Dart Aerospace Ltd. 815 07/06/05 Fridny, 5/25/2007 8:37:41 AM wom Johnston **Process Sheet** : BRACKET Drawing Name : CU-DAR001 Dart Helicopters Services Customer Job Number : 32661 Estimate Number : 12811 : D35921 : NIA Part Number P.O. Number D3592 REVA S.O. No. : NIA **Drawing Number** : 5/25/2007 This Issue :-N/A Project Number Prsht Rev. : REVA : NIA : SMALL /MED FAB Type **Drawing Revision** First Issue : NA : 6/10/2007 : 32003 Material Previous Run Each Due Date Written By Checked & Approved By New Issue 07-03.26 : Est Rev:A Comment Additional Product Job Number: Machine Or Operation: Description: Seq. #: 6061-T6 .125 Sheet 1.0 M6061T6S125 Comment: Qty.: 17.5140 sf(s) 0.1460 sf(s)/Unit Total: 6061-T6 .125 Sheet Batch: MAHAL M104366 WATER JET Comment: FLOW WATER JET 07 06 04 1-Cut as per Dwg D3592 Dwg Rev: 7 Prog Rev: 2-Deburr if necessary INSPECT PARTS AS THEY COME OFF MACHINE 3.0 QC2 Comment: INSPECT PARTS AS THEY COME OFF MACHINE 4.0 QC8 SECOND CHECK 125 Comment: SECOND CHECK SMALL & MEDIUM FAB RESOURCE 1 Comment: SMALL & MEDIUM FAB RESOURCE 1 Form as per Dwg D3592 using DT8949

DART AEROSPACE LTD	Work Order:	32661
Description: Bracket	Part Number:	D3592-1
Inspection Dwg:

- LICSUE	DESIGN	O DRAWN BY		ROSPACE LTD RY, ONTARIO, CANADA
THE WALL BOOK	CHECKED	APPROVED	DRAWING NO. D3592	Ra. B REV. A SHEET 1 OF 1
DALLIMIN 01.06.04	DATE (7.01.15	PLATE	SCALE 1:1
	A	07.01.15	NEW ISSUE	
	В	07.05.31	TOOLING HOLES A	DDED

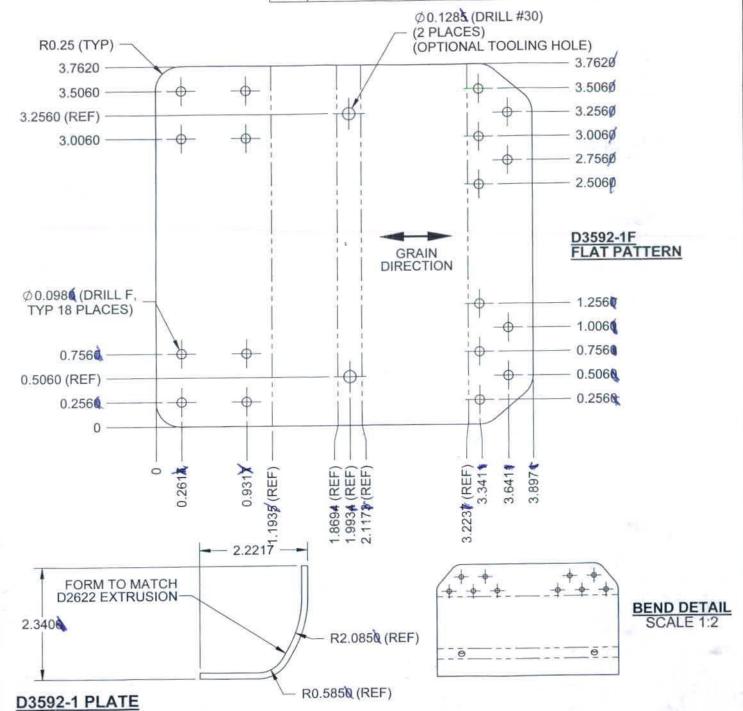
Essentially, the revision will consist of adding two 0.128 dia. tooling holes to assist in bending the part.

I already talked to you about this. They want to put two 0.128 dia tooling holes to assist in bending the part. Referencing the attached dwg, the holes will be placed on the flat section between the two bends (between ordinals 1.869" and 2.117"). Is this acceptable?

Yes ... this is acceptable.
